INSTRUCTION TO SERVICE

ITS: 58663

SECTION:	580 Wheelchair Ramp
WRITTEN BY:	James Ashdown
SUBJECT:	Kneeling Buzzer Replacement

Figure 3 – New Kneeling Buzzer (P/N 795862)

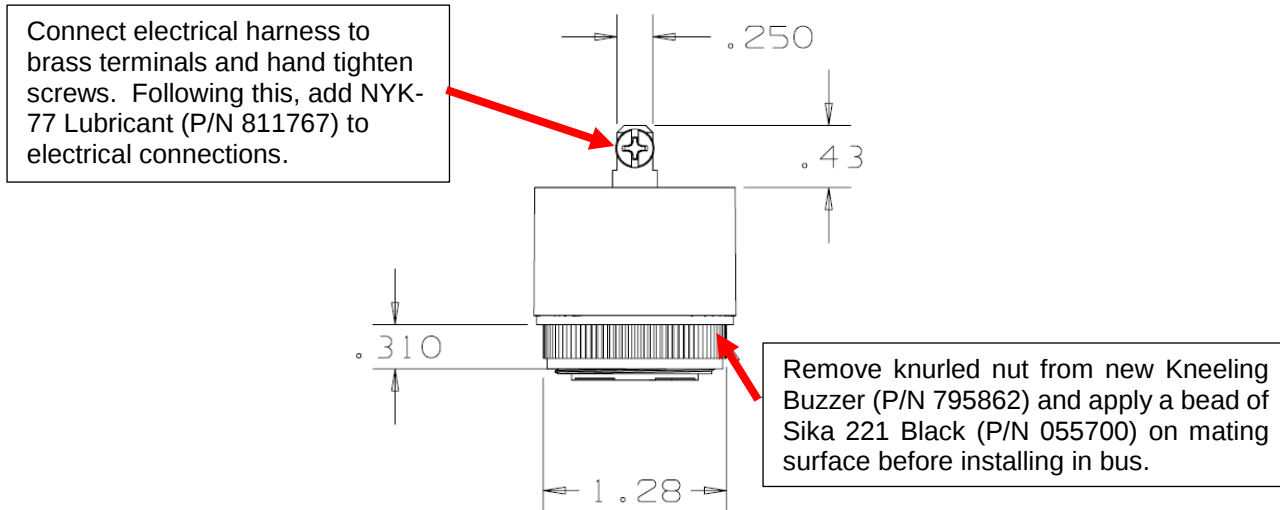
PROBLEM DESCRIPTION: Kneeling buzzers are failing prematurely due to salt/water intrusion.

SOLUTION: Replace existing kneeling buzzer with new IP68 rated kneeling buzzer P/N 795862.

5. Remove both screws and disconnect the electrical harness from the Kneeling Buzzer terminals.
6. Gently pull Kneeling Buzzer upwards out of the front mask and remove from the bus.
7. Gently clean remaining Sika from hole in the front mask.
8. Remove knurled nut from new Kneeling Buzzer (P/N 795862) and install threaded front in existing hole in the front mask. Refer to Figure 3.

Note: Apply a light bead of Sika 221 Black (P/N 055700) on the mating face of buzzer before installing.

9. Reconnect the electrical harness to the brass terminals on new Kneeling Buzzer (P/N 795862) by hand tightening screws. Following this, add NYK-77 Lubricant (P/N 811767) to the electrical connections. Refer to Figure 3.
